2024/5410/P

72 Camden Mews NW1 9BX

Subject: Fwd: [72 Camden Mews NW1](#)

MASSING & OUTLOOK
74CM REAR

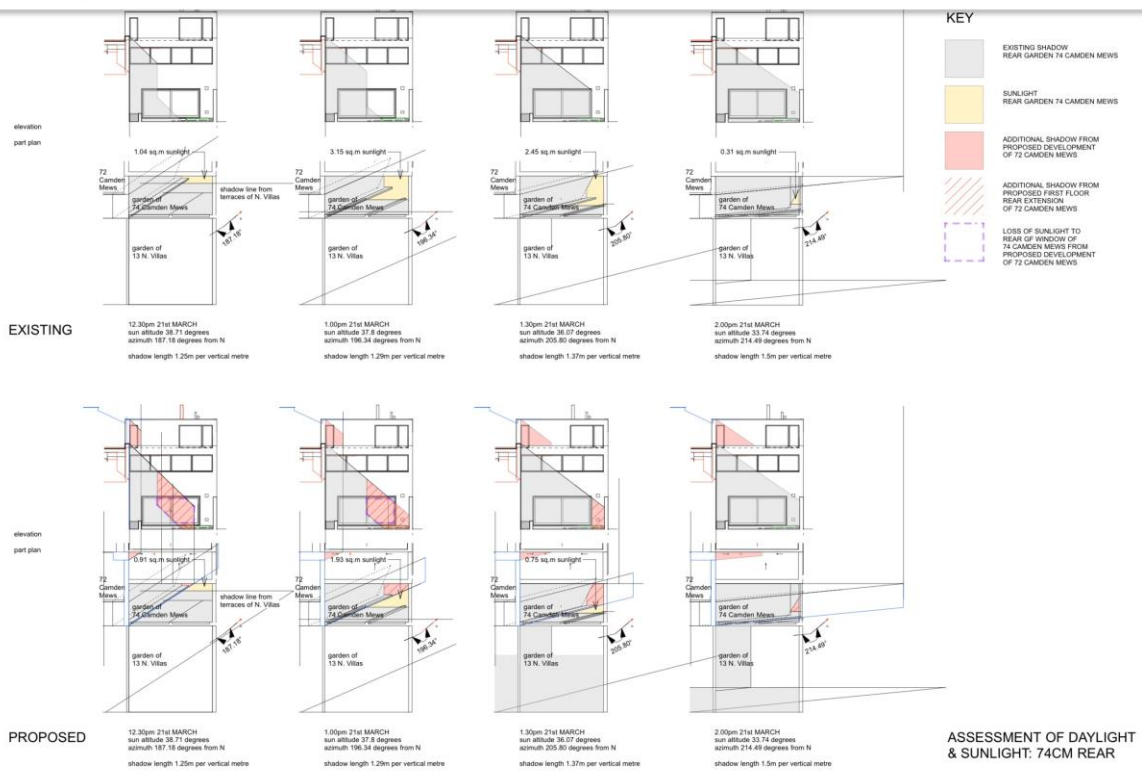
However , what appears to have been neglected is the affect of the two storey party wall extension at the rear of the property where it adjoins [74 Camden Mews](#) and also 11 and [12 North Villas](#).

PROPOSED EXTENSION
CASTING SHADOWS TO 74.

REPRESENTS MASSING OF
PROPOSED REAR ADDITIONS TO 72 CAMDEN MEWS
TO DEMONSTRATE NEGATIVE IMPACT ON OUTLOOK

REFER TO OTHER DRAWINGS FOR DEMONSTRATION
OF INCREASED OVERSHADOWING & LOSS OF SUNLIGHT

VIEW FROM EYE LEVEL
REAR GARDEN OF 74 CAMDEN MEWS
